**STAFF REPORT**  
(One Step Final Plat)

**CASE NUMBER:** S/D 99-75 -- HILLSIDE PARK ADDITION

**LOCATION:** Northeast corner of Hillside and 69<sup>th</sup> St. North

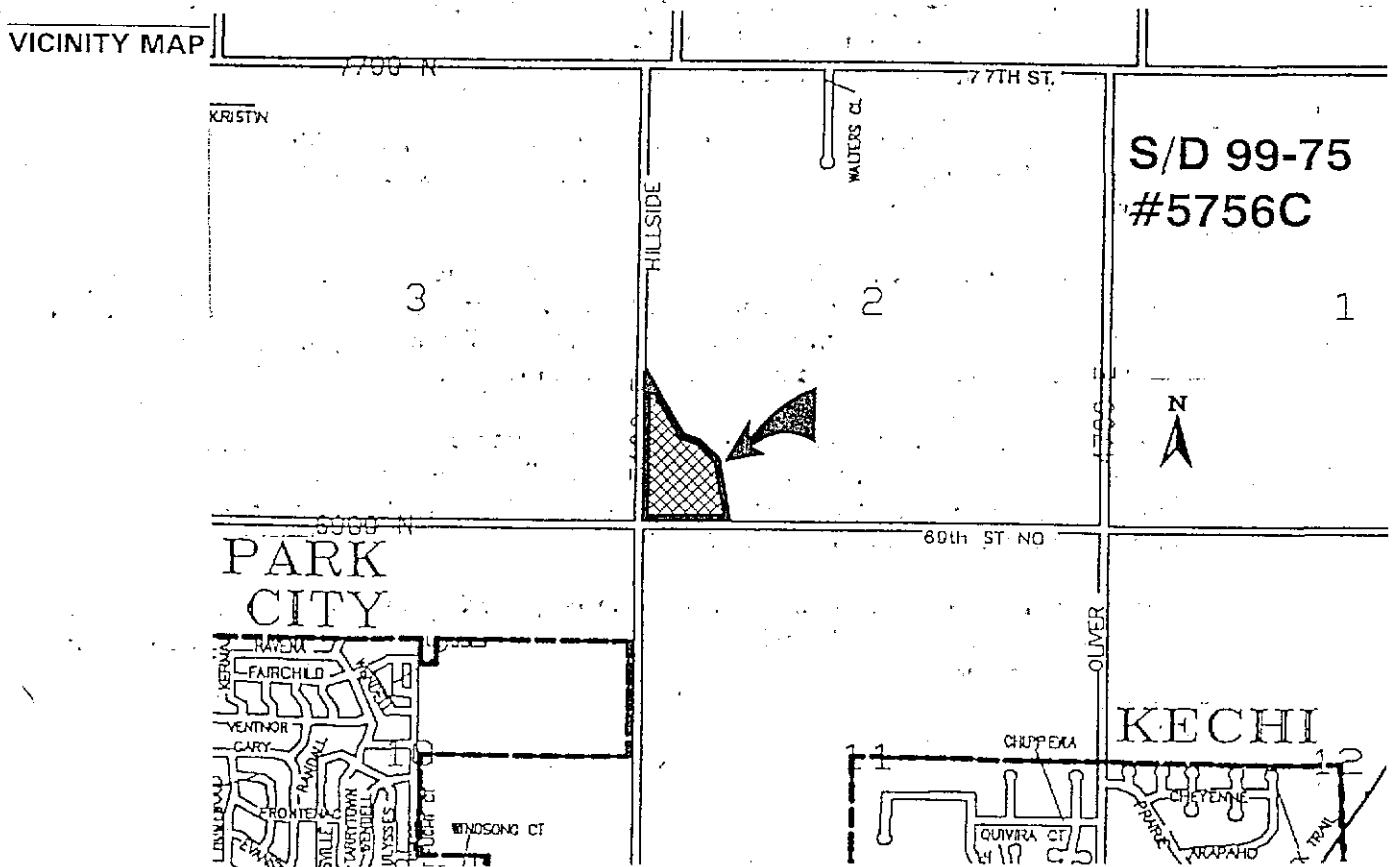
- C. County Engineering needs to comment on the status of the applicant's drainage plan and accuracy of the minimum building elevations platted.
- D. County Engineering needs to comment on the access controls. The face of the plat shall denote the access controls as referenced in the plat's text. The plat's text shall be revised to reference the "west" line of Lot 2.

- E. The MAPC Chairman needs to be revised to reference "Francis S. Garofalo".
- F. If platted, the building setback may be reduced to 35 feet.
- G. For those reserves being platted for floodway purposes, a covenant shall be required which provides for ownership and maintenance of the reserves and shall grant, to the appropriate governing body, the authority to maintain the floodway reserves in the event the owner(s) fail to do so. The covenant shall provide for the cost of such maintenance to be charged back to the owner(s) by the governing body.

- I. The plat's text shall include language that a drainage plan has been developed for the plat and that all drainage easements, rights-of-way, or reserves shall remain at established grades or as modified with the approval of the applicable City or County Engineer, and unobstructed to allow for the conveyance of stormwater.
